ASSESSMENT REPORT

North Cooranbong Concept Plan MP 07_0147 MOD 4

Figure 5: Approved and Proposed Alignment of the Local Road Servicing the Southern Catchment (Source: Environmental Assessment for MP 07_0147 Mod 4)

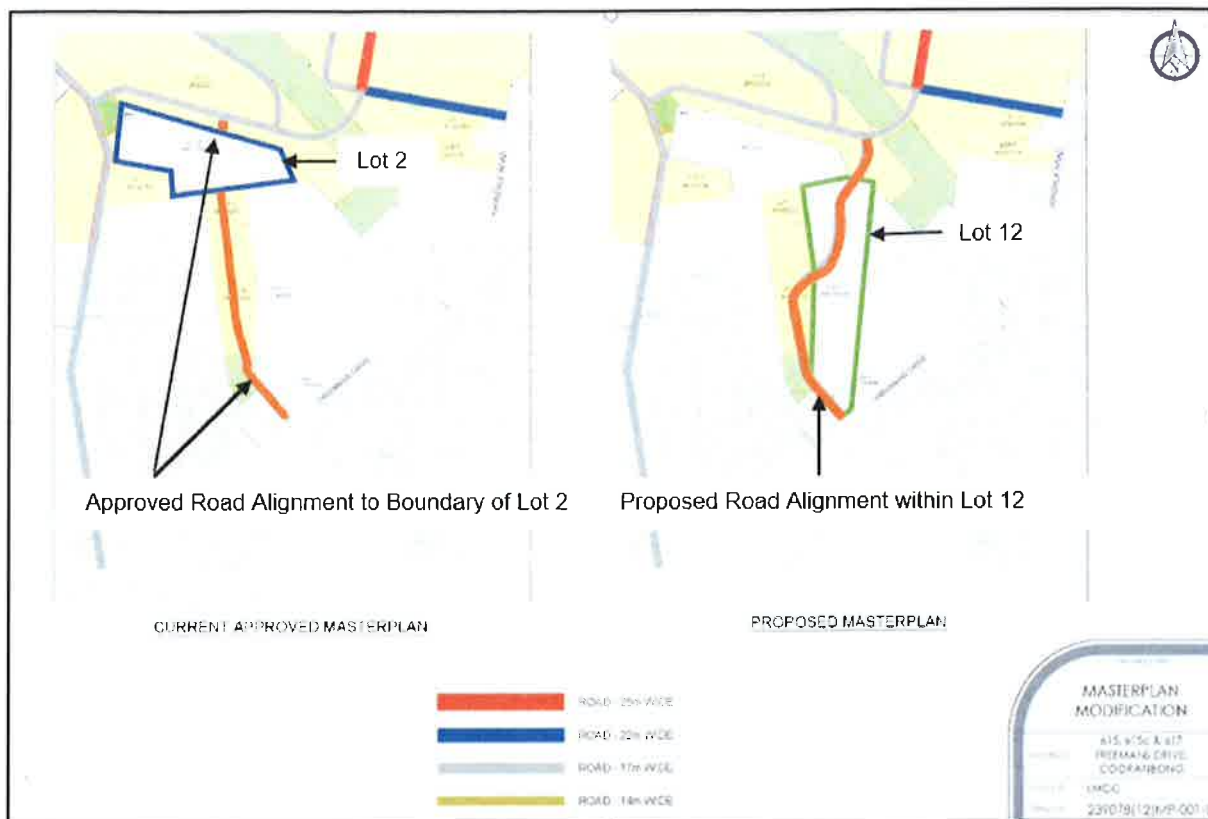
The approved and proposed alignment of the local road servicing the southern catchment is depicted in **Figure 5**.

The Proponent has advised the modification is sought to provide an alternate local road alignment on land under JPG's control. Lot 2 shown outlined in blue in **Figure 5**, is not owned by JPG and does not form part of the Concept Approval.

- Council supports the width of the proposed road reserve and carriageway (17 metre (m) wide road reserve and 9 m wide carriageway proposed). However, the Proponent should demonstrate the following design requirements can be met prior to the determination of the modification request:
 - a minimum curved radii of 120 m can be provided
 - the road design speed would not exceed 50 km/hr
- the Proponent should demonstrate how access will be provided to Lot 2.

- the alignment of the proposed local road should be revised to correspond with the boundary of the E2 and R2 zones on Lot 12
- a 30 m wide vegetation corridor should be provided along the eastern boundary of the site to provide consistency with the NSW Land and Environment Court judgement for DA/714/2014
- the proposed development will result in the removal of two plant species listed as 'vulnerable' under the *Threatened Species Conservation Act 1995* (TSC Act) and the *Environmental Protection and Biodiversity Conservation Act 1999* (EPBC Act) and offsets should be provided to compensate for their loss
- all offsets should be calculated in accordance with the OEH's Biobanking Methodology and secured in perpetuity.

Figure 7: Location of 30 m wide Vegetation Buffer Required under Condition 11 of DA/714/2014 (Source: Supplementary Information Provided by JPG dated 21 July 2017)

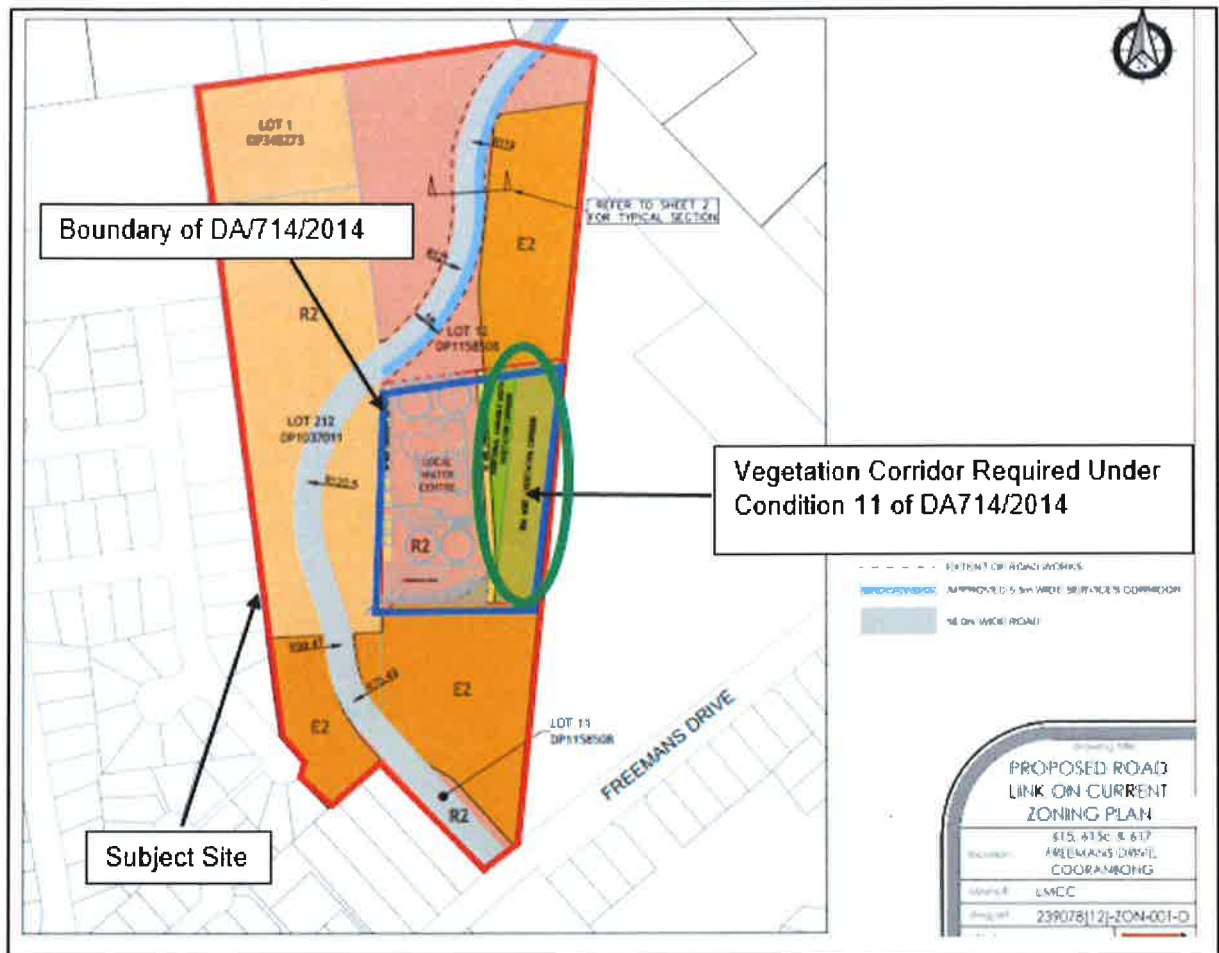
- the proposed road alignment has been revised to generally align with the boundaries of the R2 and E2 zones (see **Figure 7**)
- Council and the OEH have advised the proposed offset arrangements would be sufficient to mitigate the impact of additional vegetation clearing on Lot 12. This offset can be obtained via the inclusion of a new assessment requirement for suitable arrangements to be in place to secure the proposed offset prior to the determination of any development application proposing to clear *Tetraetheca juncea* or *Angophora inopina* on Lot 12

- the application would not remove vegetation within the corridor required under Condition 11 of DA/714/2014 (see **Figure 7**)
- the technical reports prepared to support recent development applications on Lot 12 confirm the area within the proposed road reserve is not subject to flooding or mine subsidence, and does not contain any contaminated or acid sulphate soils

Figure 8: Removal of North-South Road to Lot 2 (Source: North Cooranbong Concept Plan RTS)

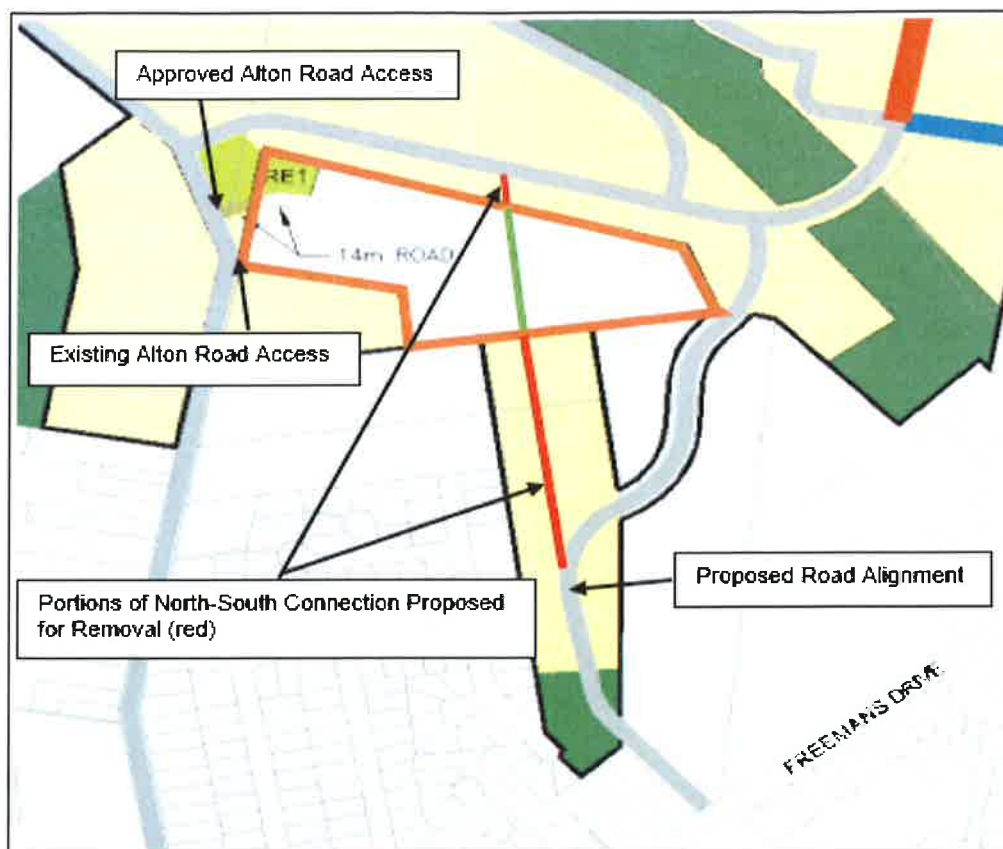
The approved Concept Plan includes a north-south road running through Lot 2. However, this connection is now sought to be removed and replaced with a new road running through Lot 12, further to the east (see **Figure 8**).

Lot 2 does not form part of the Concept Approval as the owner of Lot 2 did not consent to being part of the original application. The owner of Lot 2 raised concerns about the removal of the north-south road adjacent to Lot 2, as it would:

- remove the opportunity to provide north-south connectivity within and to Lot 2, and reduce the potential design options available for the redevelopment of this lot
- potentially alter the timing for the redevelopment of Lot 2, as the redevelopment of this lot would rely solely on the provision of the road connection adjacent to the western boundary of the site on land controlled by the Proponent.

The Department notes access to Lot 2 is currently constrained as it only has a five-metre wide frontage to a bend on Alton Road. Access to Lot 2 is currently provided via an unconstructed road (known as Alton Road North) which is controlled by the Proponent. Alton Road North does not form part of the approved Concept Plan and instead, this area will be occupied by a small park and a new access roadway to Lot 2 (**Figure 8**).

The Department's assessment therefore concludes, subject to the retention of the northern road connection to Lot 2, the removal of the southern road connection and its replacement with a new road alignment to the east, would provide an acceptable level of connectivity all for lots within and adjoining this part of site. The Department has, therefore, recommended a new modification to the Concept Plan (Modification 2.4) requiring the retention of the access road/access point adjacent to the northern boundary of Lot 2.

Figure 9: Connectivity Plan (Source: Proponent's Supplementary Information dated 19 July 2017)

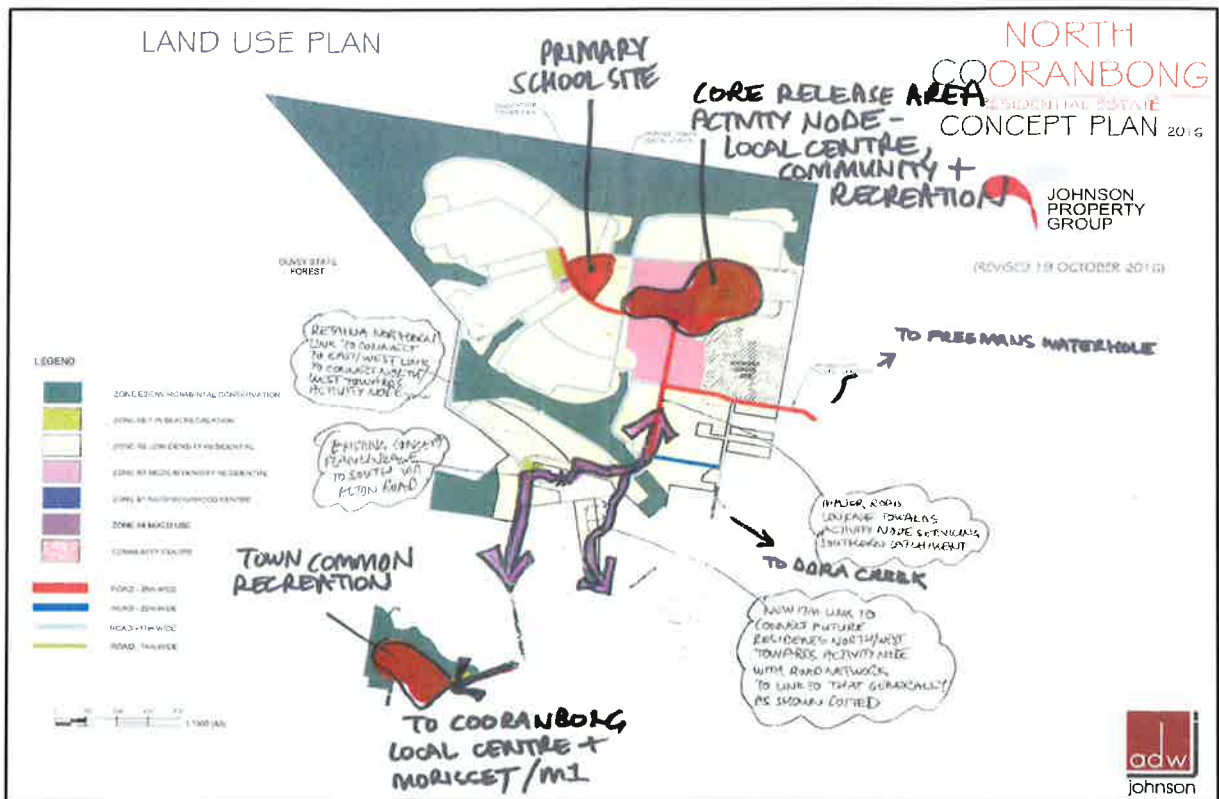
The Department reviewed the Proponent's RTS and requested additional information to demonstrate the relocation of the north-south road would not reduce connectivity within the southern catchment of the site, or adversely impact the redevelopment options for Lot 2. In response to these concerns, the Proponent provided supplementary information on 19 July 2017, advising a second road connection could be provided by condition at the northern boundary of Lot 2 and would achieve the connectivity outcomes identified by the Department. To ensure suitable connectivity is provided to Lot 2, the Proponent suggested modifying the terms of the Concept Approval to require the retention of the road adjoining the northern boundary of Lot 2.

The Department considers the revised proposal, which retains two of the three approved connections, is acceptable as it would provide appropriate levels of access and connectivity and appropriate development options for the future redevelopment of Lot 2. In particular, the Department considers:

- the approved access along the western boundary of the site would provide sufficient access and connectivity to Alton Road, Freemans Drive, the Avondale Shopping Village, Cooranbong and the Pacific Highway/M1 to the south
- retaining a road connection along the northern boundary of the site would provide suitable connectivity to future parks, shops and community facilities located to the north of the site
- removal of the southern access to Lot 2 would not materially impact on the development potential for subdivision of Lot 2 and subject to minor design amendments, would not preclude the delivery of lots in the general configuration identified in the local VPA, (see **Figure 10**).
